# Planning Commission Agenda

**Discretionary Use - Request Discretionary Use Approval Steven Wages, Springfield Utility Board,**  
**Applicant: TYP316-00001**

**Staff Report and Findings  
Springfield Planning Commission  
Discretionary Use Request (Springfield Utility Board)**

# TYPE II TENTATIVE SITE PLAN REVIEW, STAFF REPORT & RECOMMENDED CONDITIONS

20. OUTLET FROM RESERVOIR OVERFLOW PIPING INTO ROAD SIDE SWALE. INSTALL FLAPPER VALVE

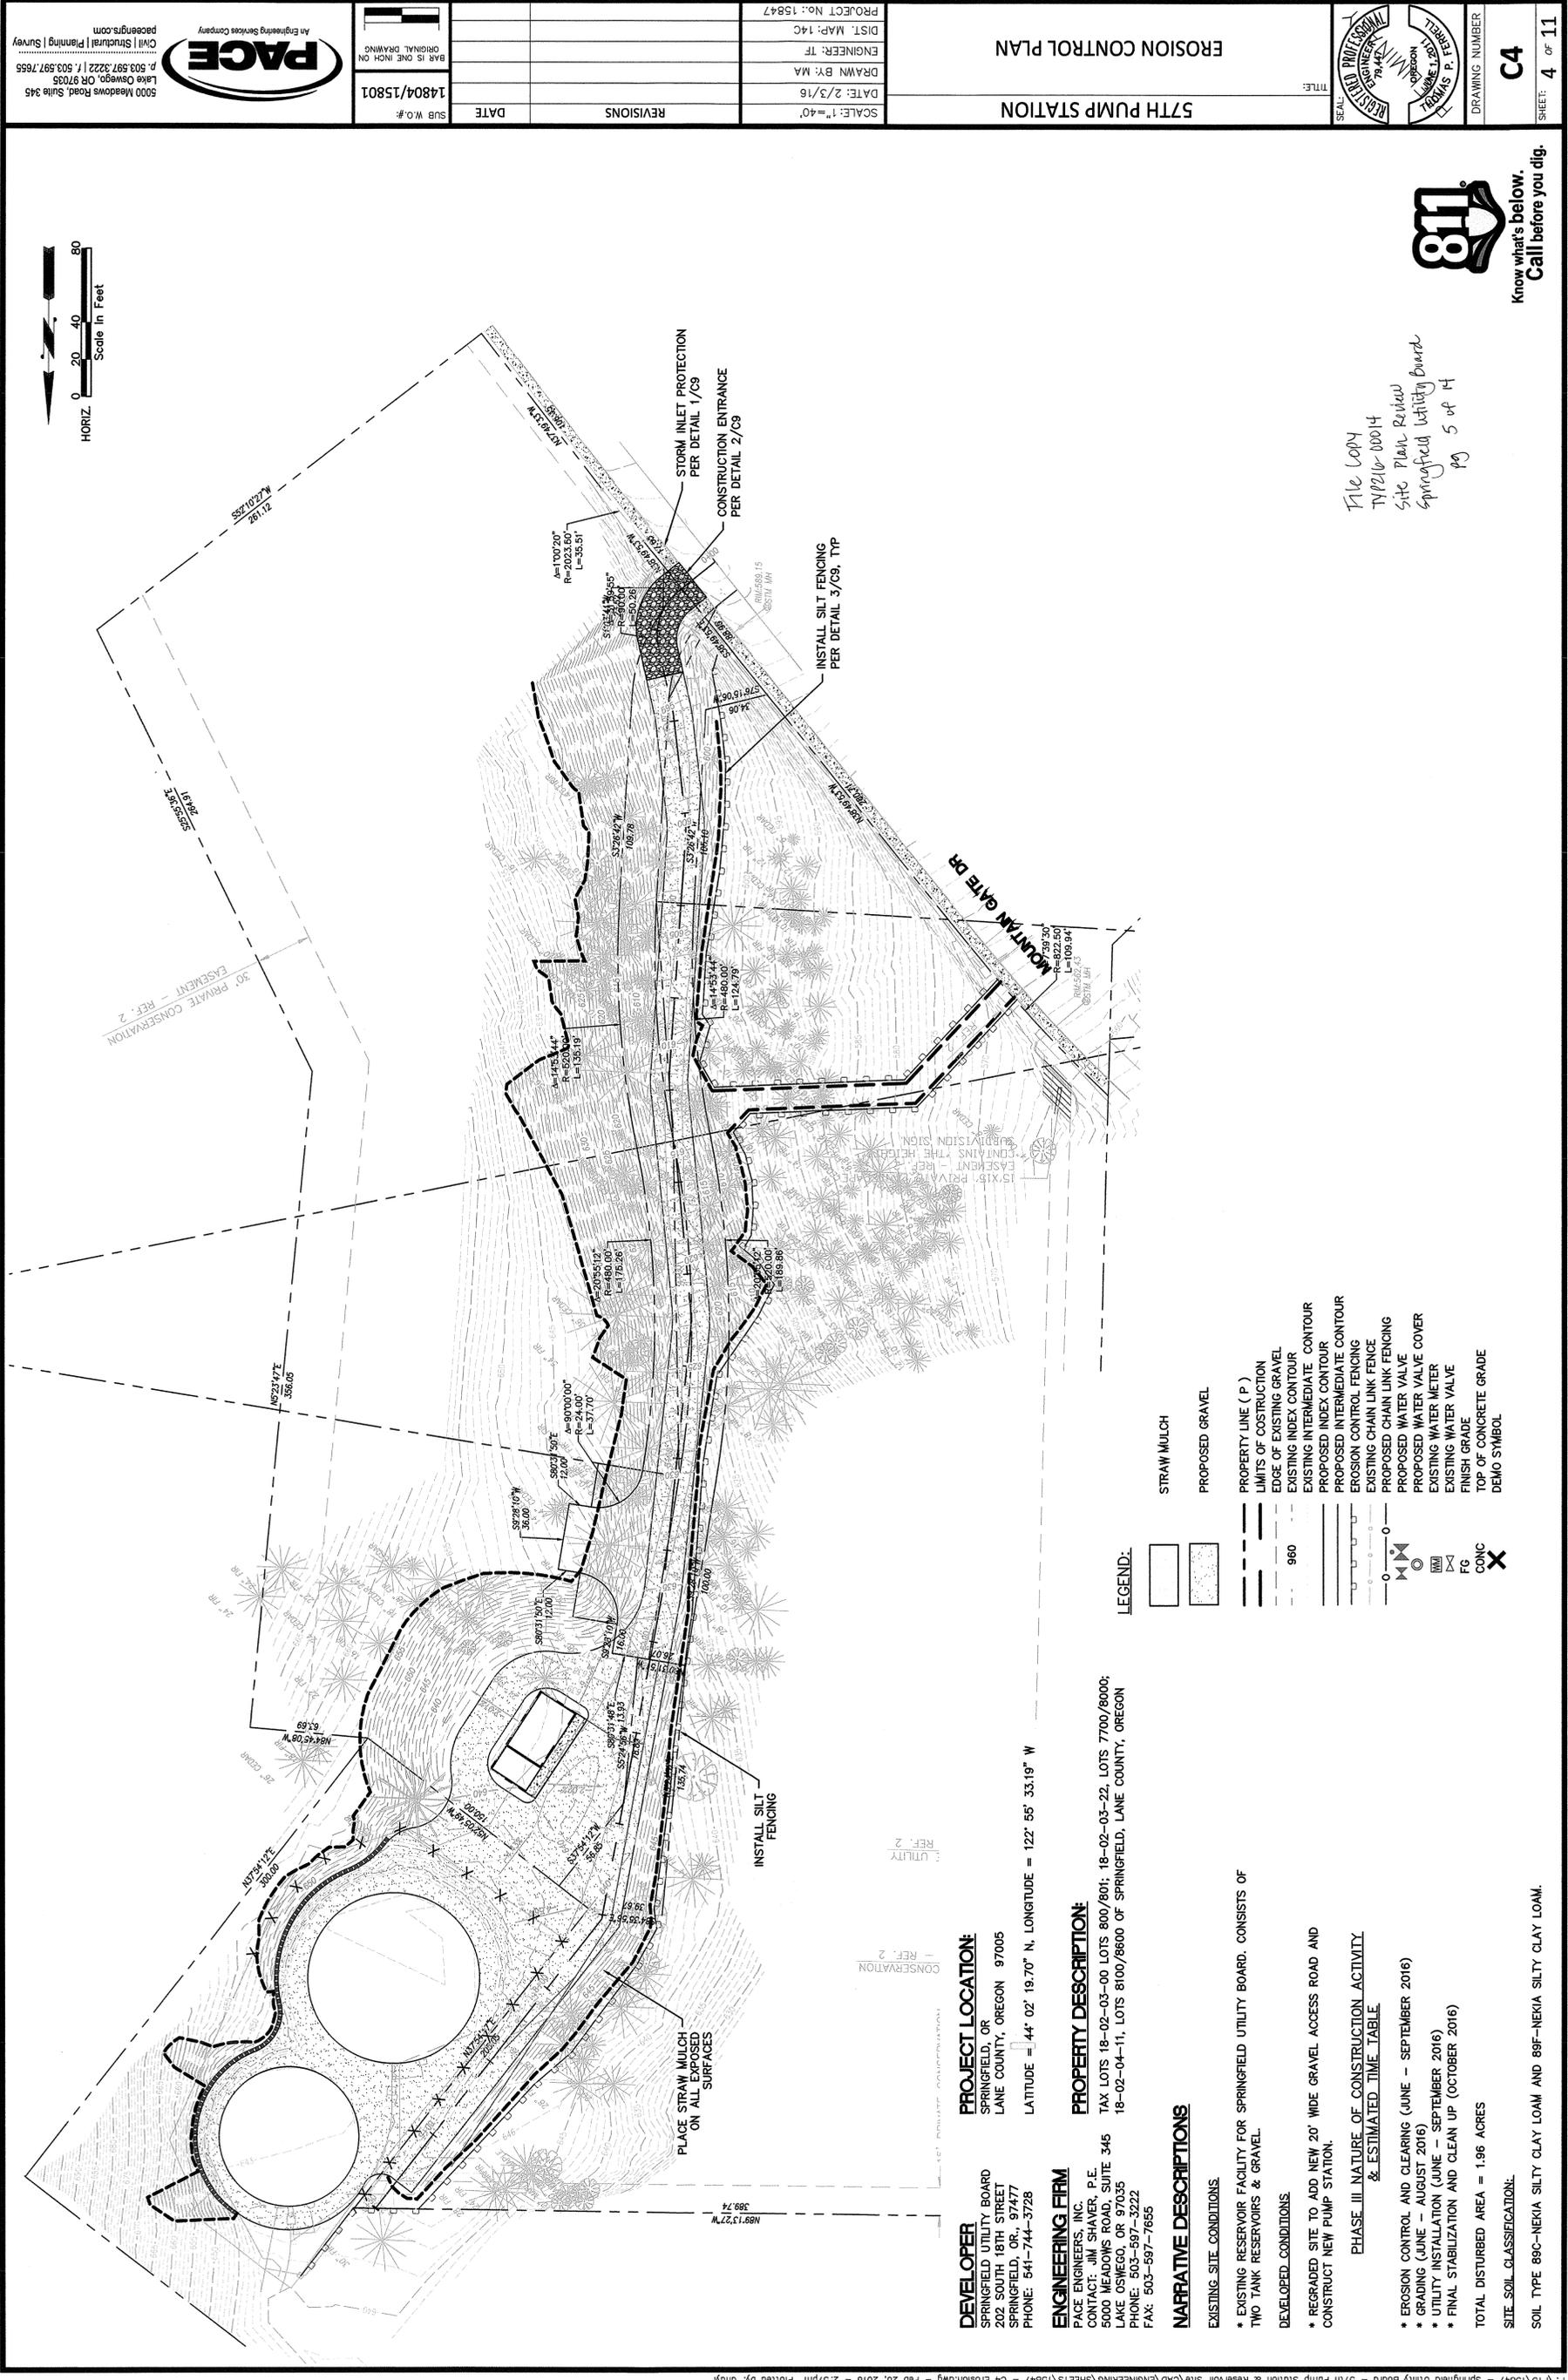
- 6. The Final Site Plan shall provide a plan detail for the flapper valve described in Construction Note 20 on Sheet C2.**
- 7. To ensure a fully functioning water quality system and meet objectives of Springfield's MS4 permit, the SDC and the EDSPM, the roadside drainage swale shall be fully vegetated with all vegetation species established prior to the Final Site Inspection. Alternatively, if this condition cannot be met, the applicant shall provide and maintain additional interim erosion control/water quality measures acceptable to the Development & Public Works Department that will suffice until such time as the roadside drainage swale vegetation becomes fully established.**
